Access Compliance Report

Public Rights-of-Way

(Curb Ramps)

Intersection ID: 31878	Main Street: LANGDEN_GATE_DR	Cross Street: WILLIAMS_GLENN_RD	Location: NE
ADA ID: EE722851F755	Ramp Type: PerpDiag	Initial Pass/Fail: Fail	Overall Compliance: No
Severity Score: 10			
Codes/Mitigation Info/Possible Solution		Field Measurements/Component Compliance

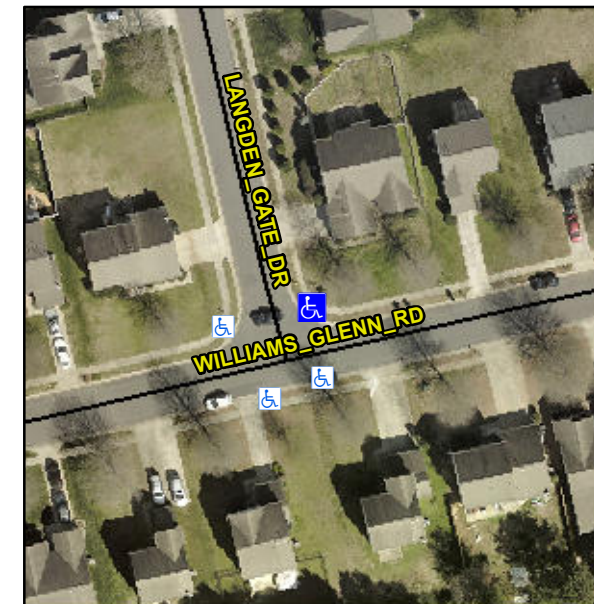
R304.5.1, R304.5.3

Compliance	Description	Data	Compliance	Description	Data
N/A	Ramp Length (in)	47.0	Yes	Ramp Slope (%)	7.8
No	Ramp Width (in)	43.0	No	Ramp XSlope (%)	2.9
N/A	Flare Type LT	N/A	N/A	Flare Type RT	N/A
N/A	Flare Slope LT (%)	N/A	N/A	Flare Slope RT (%)	N/A
N/A	Flare Traversable LT?	N/A	N/A	Flare Traversable RT?	N/A
N/A	Landing Length (in)	N/A	N/A	DWS Provided?	N/A
N/A	Landing Width (in)	N/A	N/A	DWS Contrast?	N/A
N/A	Landing Slope (%)	N/A	N/A	DWS Length (in)	N/A
N/A	Landing X Slope (%)	N/A	N/A	DWS Full Width?	N/A
N/A	Landing Curb? (Y/N)	N/A	N/A	DWS Offset (in)	N/A
N/A	Shared Landing?	N/A			
N/A	Gutter Ponding?	N/A	N/A	Gutter Slope (%)	N/A
N/A	Gutter Lip Ht (in)	N/A	N/A	Gutter X Slope (%)	N/A
N/A	Painted X Walk1?	No	N/A	Painted X Walk2?	No
	X Walk 1 Direction	To W		X Walk 2 Direction	To S
N/A	X Walk 1 Width (in)	N/A	N/A	X Walk 2 Width (in)	N/A
	X Walk 1 Slope (%)	2.3		X Walk 2 Slope (%)	0.3
	X Walk 1 X Slope (%)	0.6		X Walk 2 X Slope (%)	2.5

Remove & Replace Curb Ramp With Two New Directional Ramps or Equivalent.
